# Town of Hilton Head Island Regular Design Review Board Meeting

January 26, 2016

## DESIGN TEAM/DRB COMMENT SHEET

SCALE: AS SHOWN  
UNO  
PROJECT NO. WBHH\_1502  
SHEET TITLE ENLARGED PATIO, PLAN & DETAILS  
SHEET

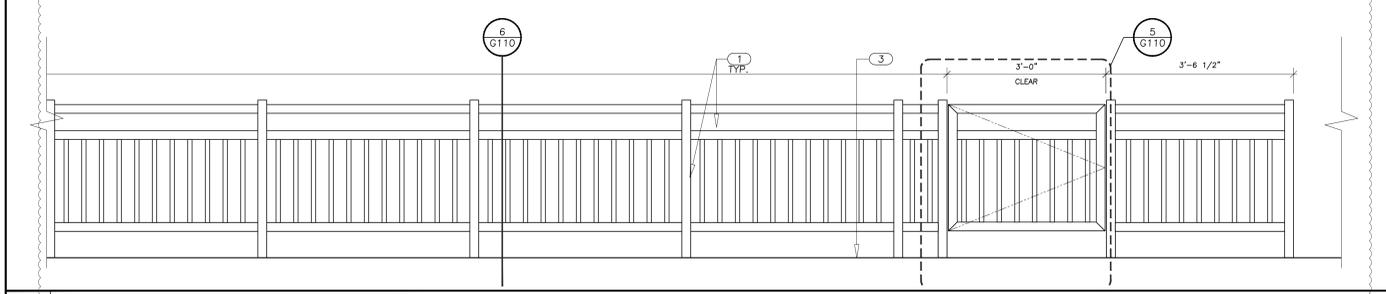
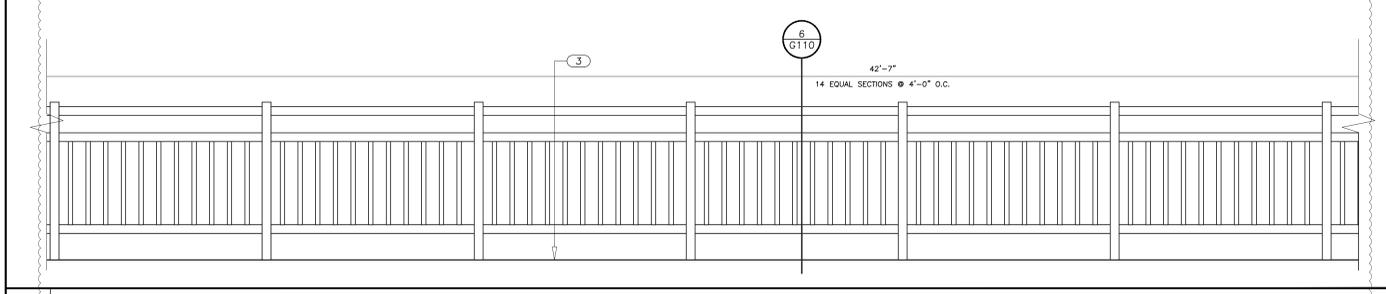
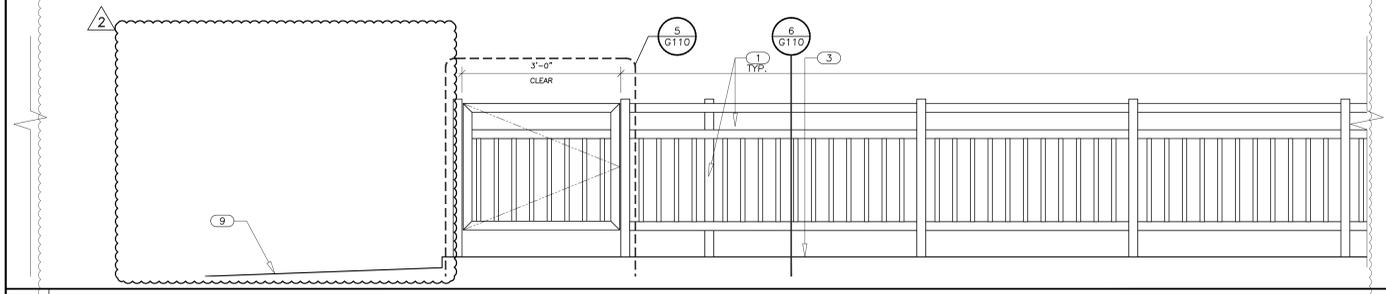
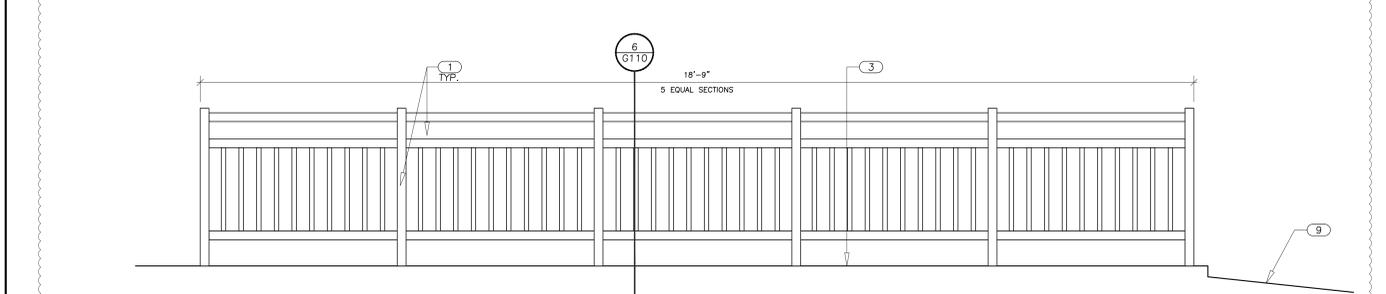
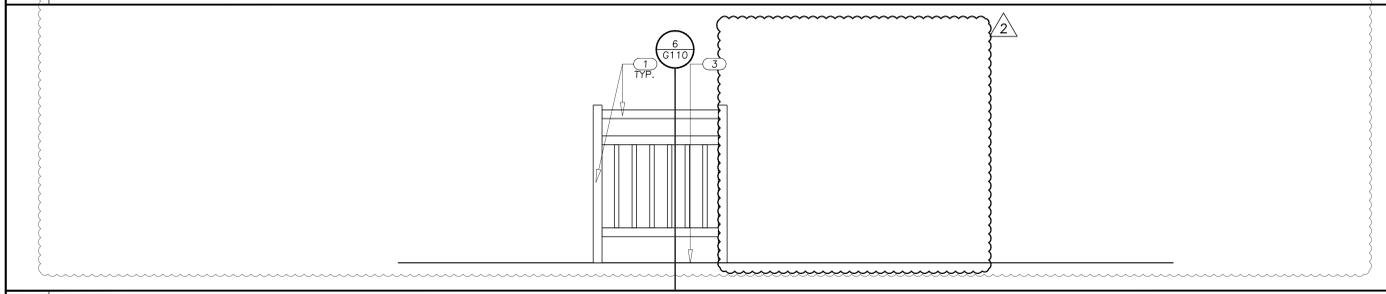
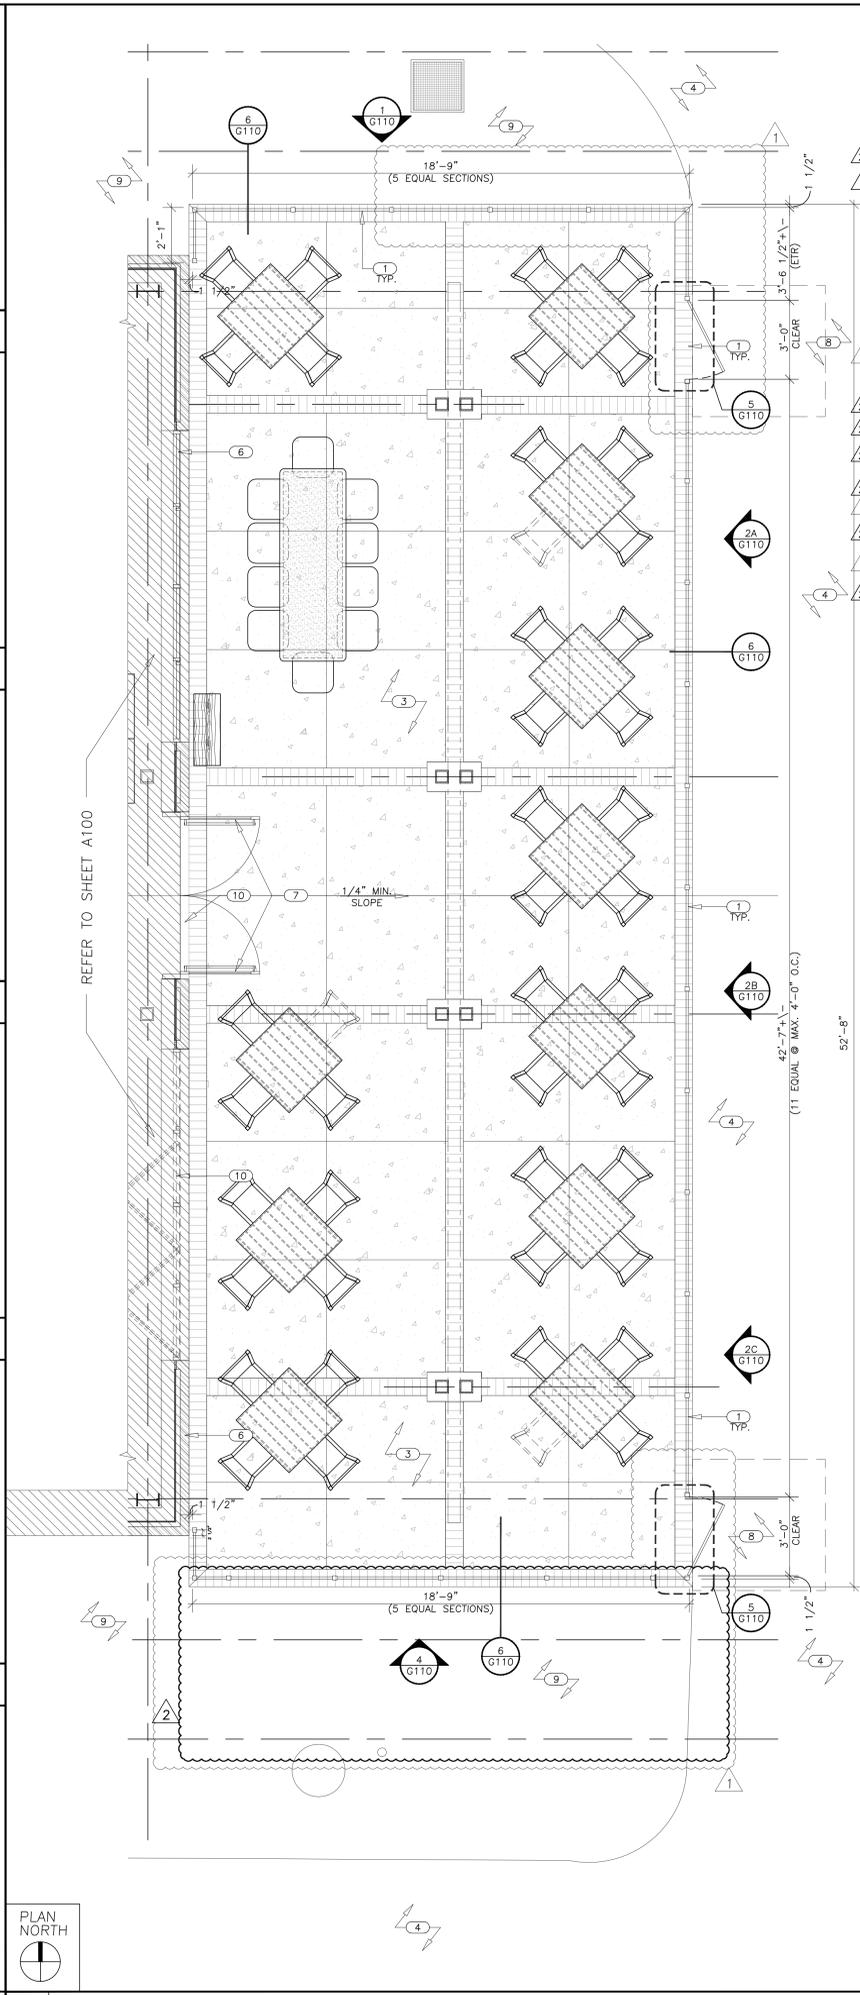
Applicant proposes to modify previously approved patio railing detail to a metal frame with picket railing. The original proposal included a rail detail with black aluminum railing and cypress rails. DRB approved the project with a condition that railing and planters should be painted to match the building (SW 6159 'High Tea'). The revised detail is a standard metal railing. Based on revised detail, the use of black metal railings in other portions of SCTC, and the use of black in the proposed signage, staff recommends approval of proposed black railing.
